FIRST AVE VILLAS

Hendersonville, NC

SHEET NAME:
COVER SHEET

UNRESOLVED COMMENTS:

Plat of Boundary Survey for

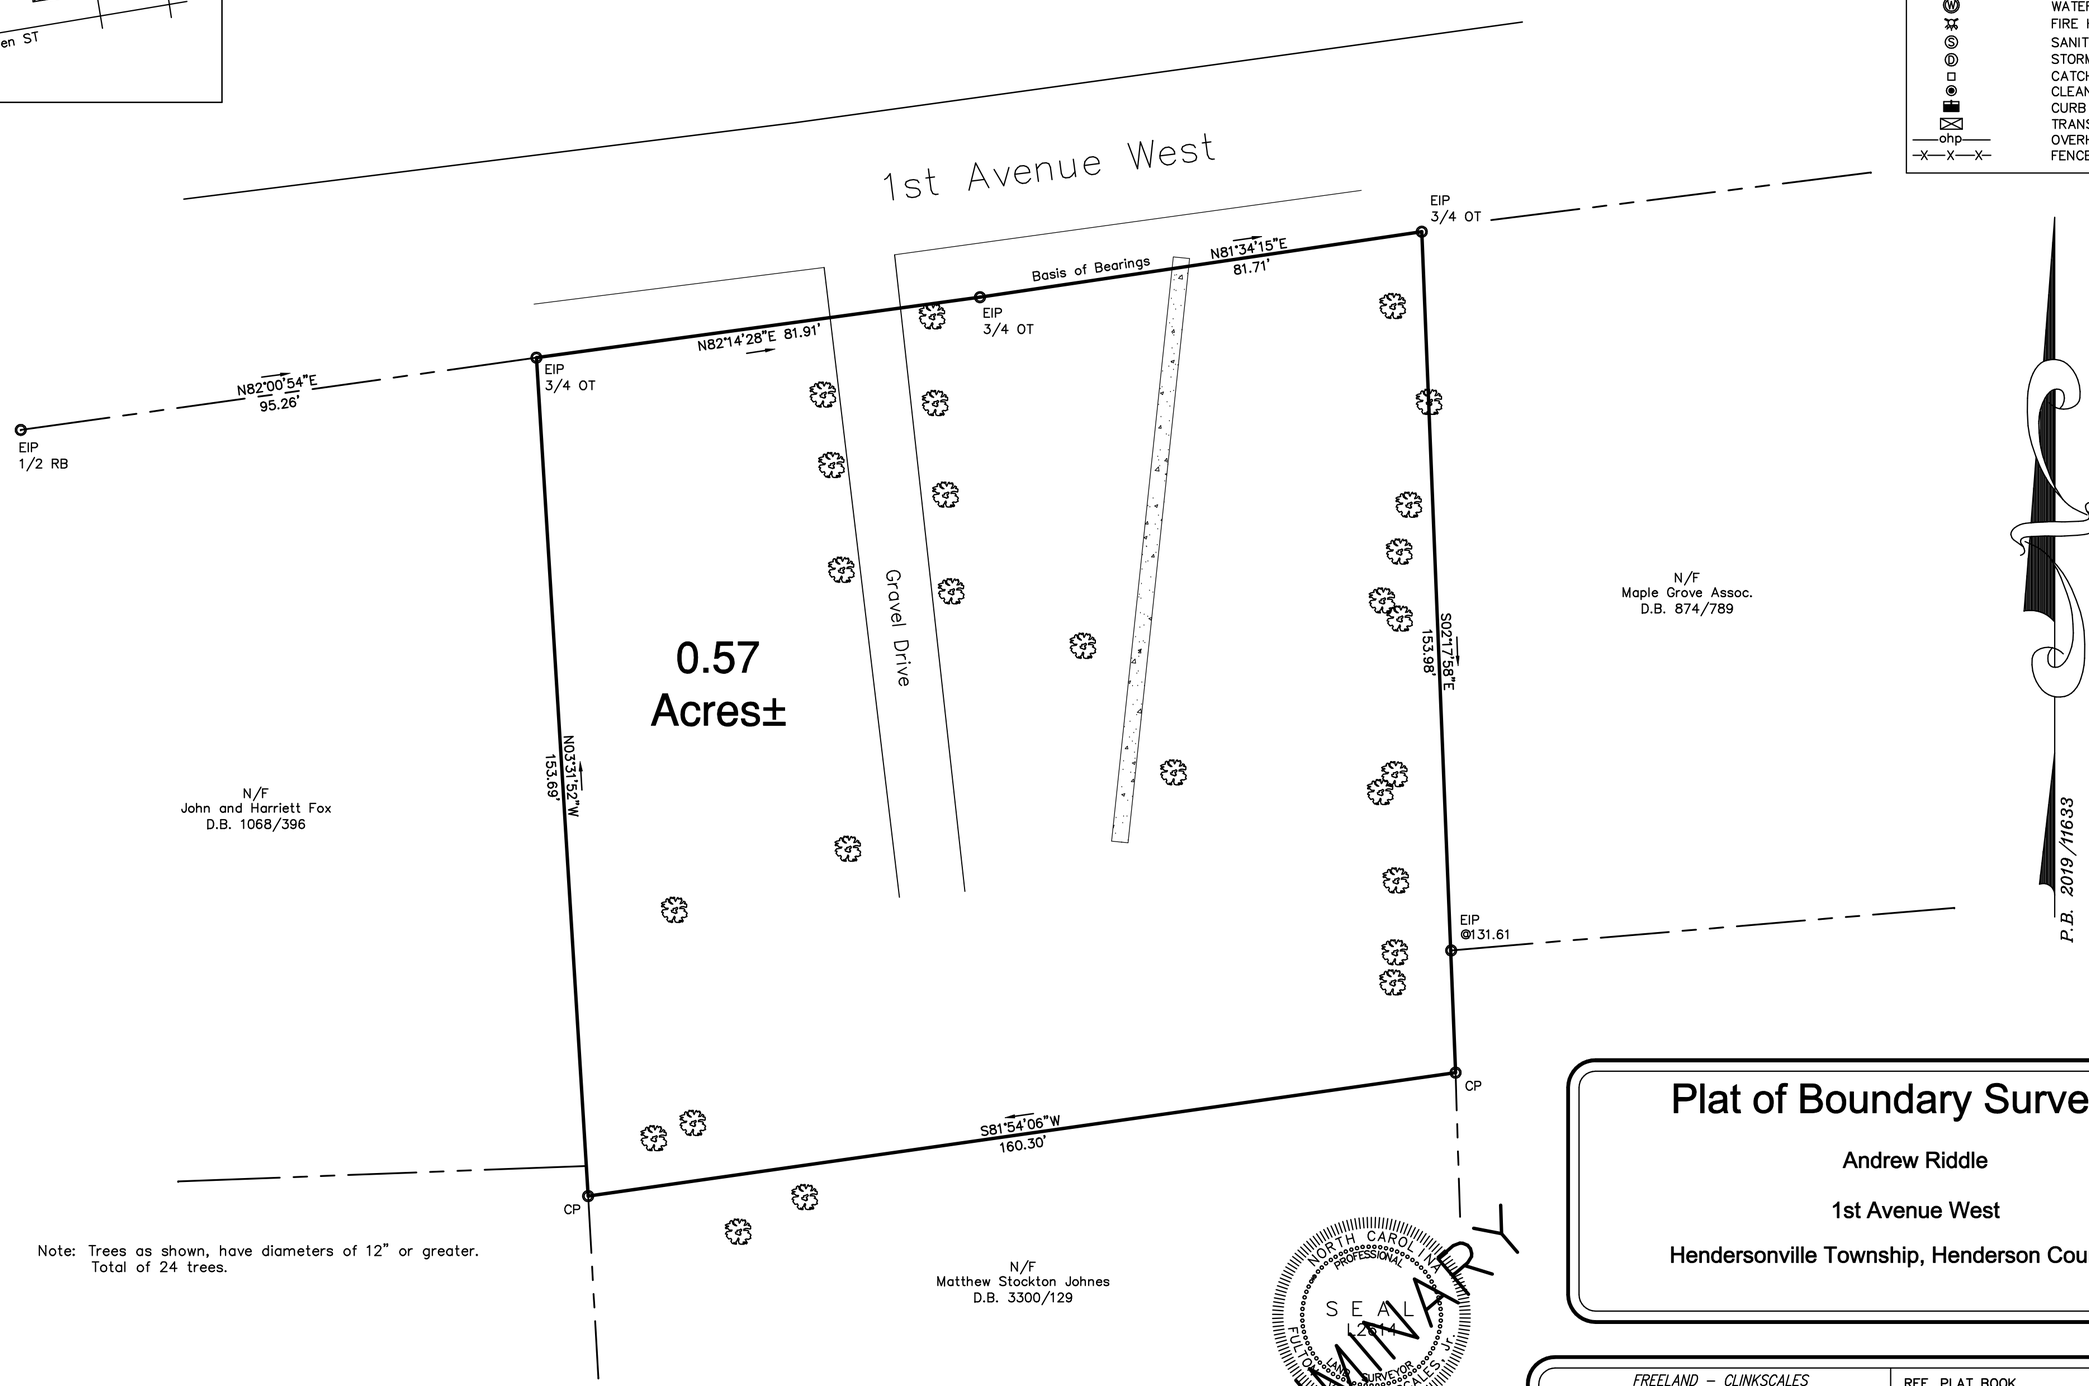
- Provide canopy area and indicate trees to be removed vs trees to be preserved on the "tree survey". [Unresolved] Trees from the tree survey to remain as well as their canopies are highlighted in black on the site plan. Previous tree canopy area provided on the site plan.

1 SP 101 **SITE PLAN**

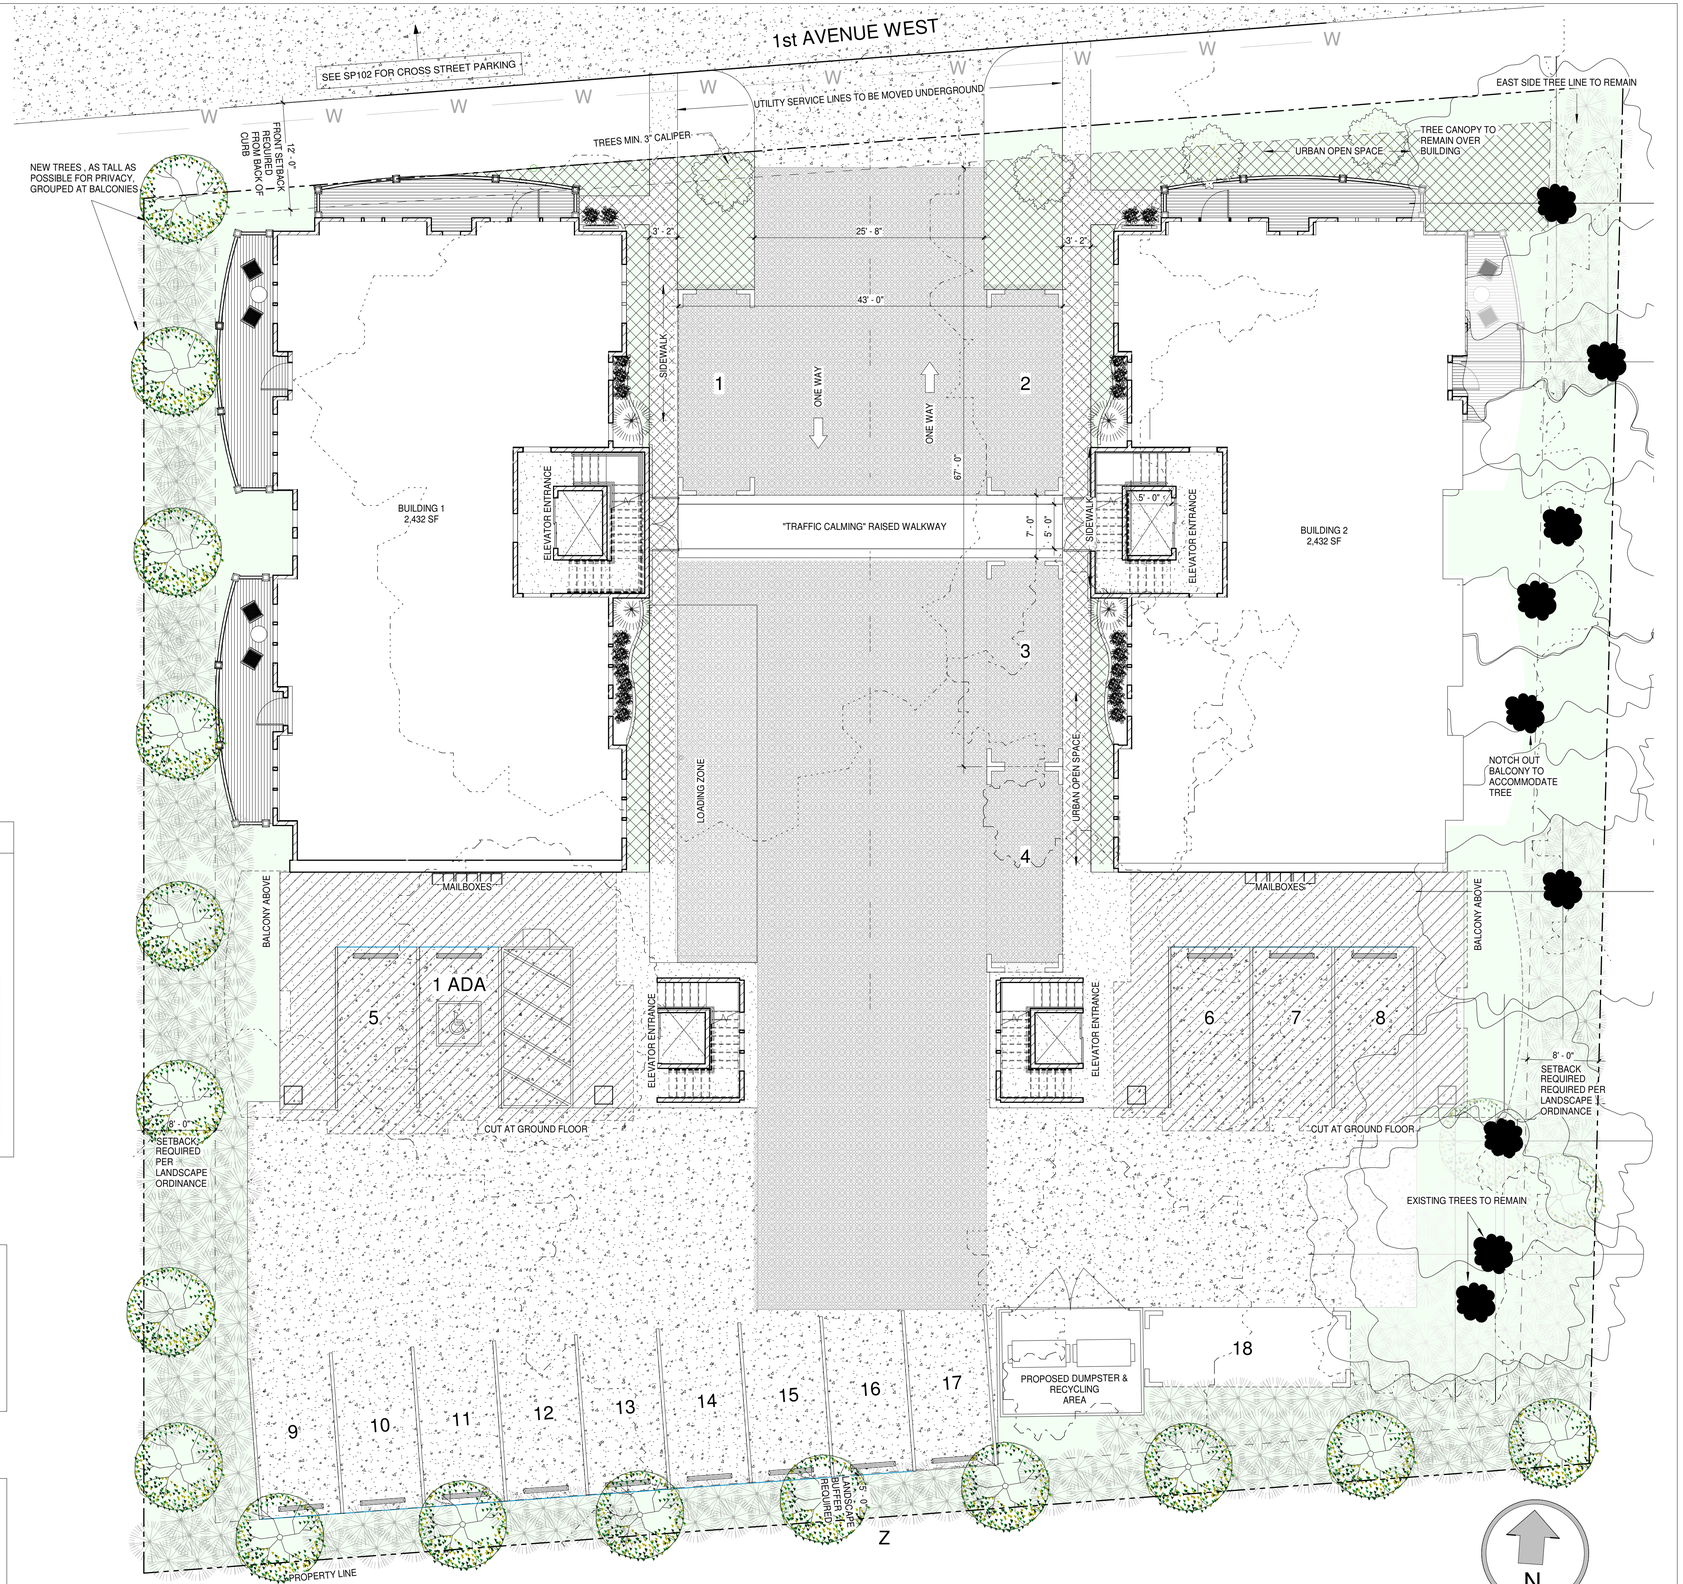
- Update Land Disturbance delineation. Appears to encompass entire parcel. [Unresolved] The proposed area of land disturbance is 19,127 SF. This is provided on the site plan. The area that is not to be disturbed is highlighted in green on the site plan.

- Clarity is needed on potential discrepancies between footprint square footage and gross floor area [Unresolved] The footprint square foot age on the first level is 2,432 sf per building. Total gross floor area is 18,832 SF. This is provided on the site plan.

- Parking Spot 11 is encumbered by a proposed tree to be preserved [Unresolved] This tree has been removed. A new tree is being proposed in its place which does not collide with the parking spots.

- Loading Zone appears difficult to access / limited in use [Unresolved] We propose moving the loading zone to the center drive aisle so that it is easier to access. This is shown in the site plan.

- Improve clarity of building footprint where surface level parking is provided under the 2nd floor [Unresolved] This has been resolved in the site plan. The area above the parking is hatched with a diagonal line pattern. In addition, the footprint above is noted with a dashed line.

- Dumpster location appears difficult to access for trash removal [Unresolved] The 24' wide T-shaped turnaround provided for the fire trucks in the back of the building will provide plenty of room for the trash truck to reach the dumpster. The dumpster is located as close to the center drive aisle as possible without being visible from the street.

- Provide sidewalk connection to street edge from first-floor units and from sidewalks which flank center-drive aisle. [Developer has agreed] This has been addressed on the site plan.

1 SP102 **STREET PARKING**
1/16" = 1'-0"

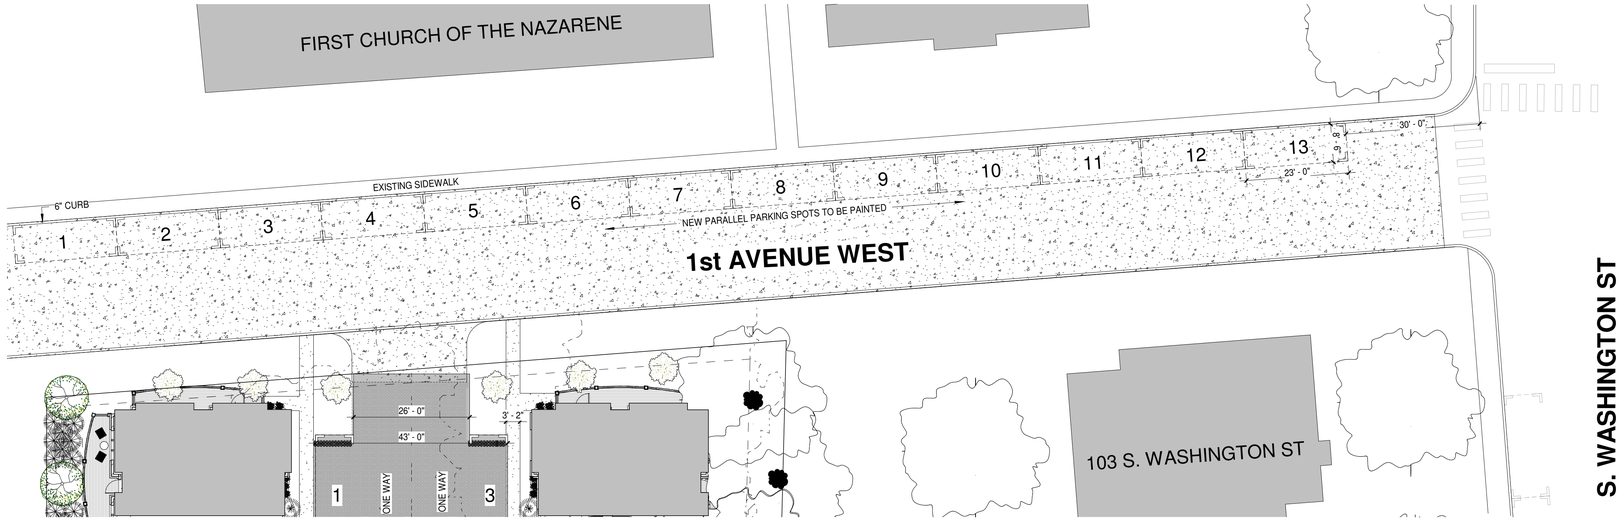
- Provide delineated on-street parking on north side of 1st Ave to address parking concerns expressed at NCM, to help buffer the sidewalks and to help achieve Strategy LU-6.4 and Action PH-3.1.1 of the 2030 Comp Plan and Sec. 5-19-3.3 of the Zoning Code - [Developer Agreed] This has been addressed. See details sheet for cross street parking.

2 SP102 **THIRD FLOOR BALCONY**
1/4" = 1'-0"

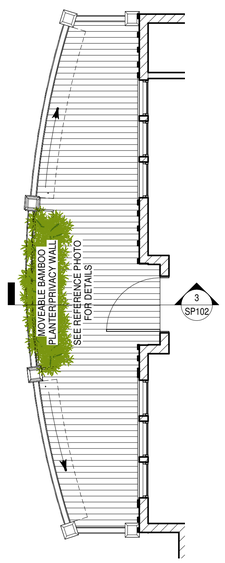
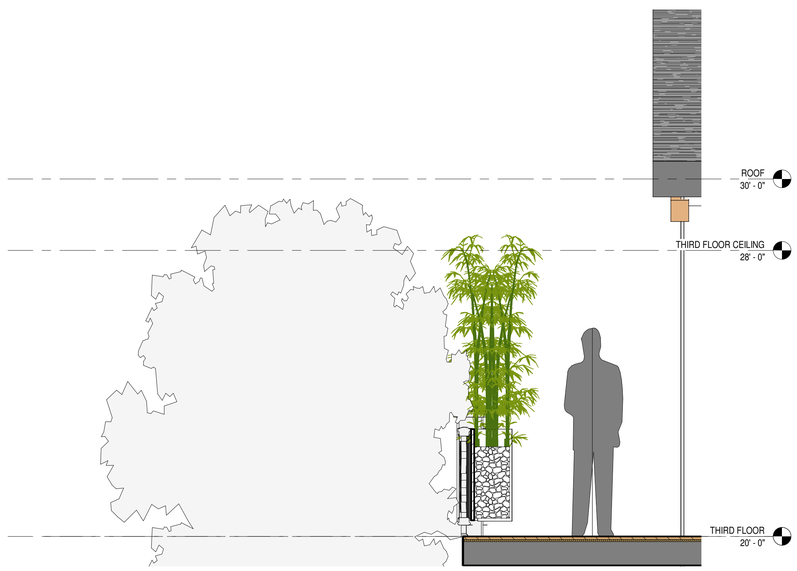
- Placement of 38' tall buildings located 8' from the property lines of adjacent single-family homes, could be considered "unreasonable loss of privacy" as is referenced in Section 18-6-1 and revisited under Sec 18-6-4.4. Further, it would have impacts to the existing neighborhood as is given consideration under Chapter 8 of the 2030 Comprehensive Plan under LU-3.5 "Minimize negative impacts from growth and land use changes on existing land uses" [Unresolved] We propose new tall trees and shrubs clustered around the balconies to create privacy on the first and second levels. On the third floor balcony we provided a movable green wall which acts as a privacy partition.

LANDSCAPING PLAN

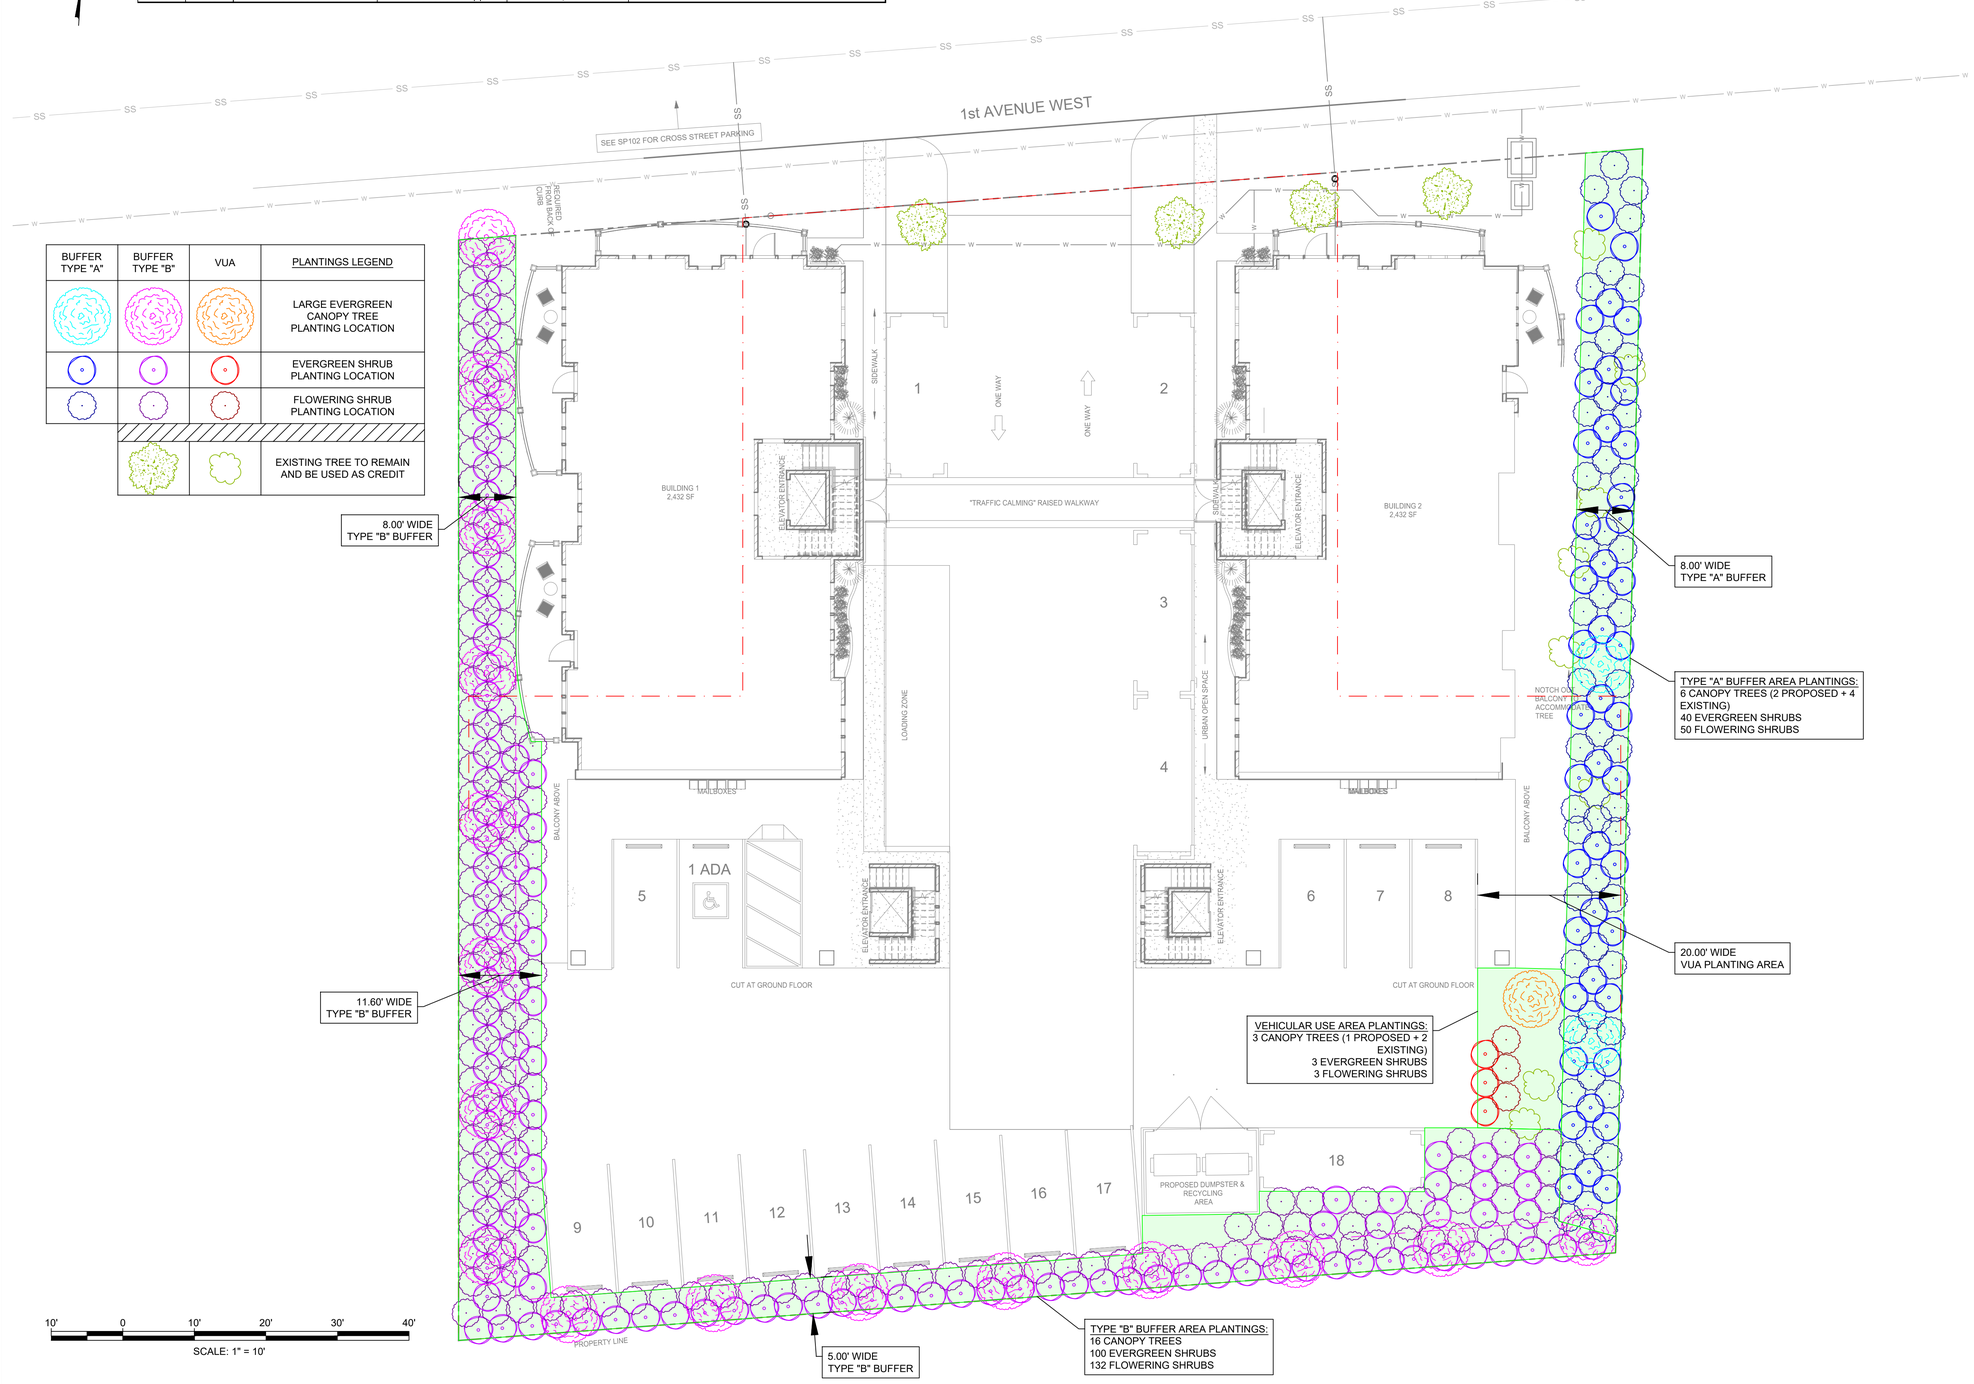
- Provide calculations for landscaping requirements. In table form, provide the area or length of required buffers, vehicular use area, urban space, etc, and provide the planting calculations required based on the zoning standards, provide the total plantings for each planting requirement. Consider separate preliminary landscaping plan on separate sheet [Unresolved] This has been provided on the preliminary landscaping plan.

- Type A Buffer Plantings as depicted are insufficient on west side property boundary. Alternative Compliance may be achieved on east property boundary at Final Site Plan. [Unresolved] Alternative compliance is achieved by maintaining all the trees on the east side property line.

- Provide solution to loss of privacy on the west side [Need solution] We propose new trees to be planted and clustered around the balconies to block the view into the neighboring houses. We also propose a movable privacy screen on the third floor balconies. The type of trees/height are detailed on the preliminary landscaping plan.
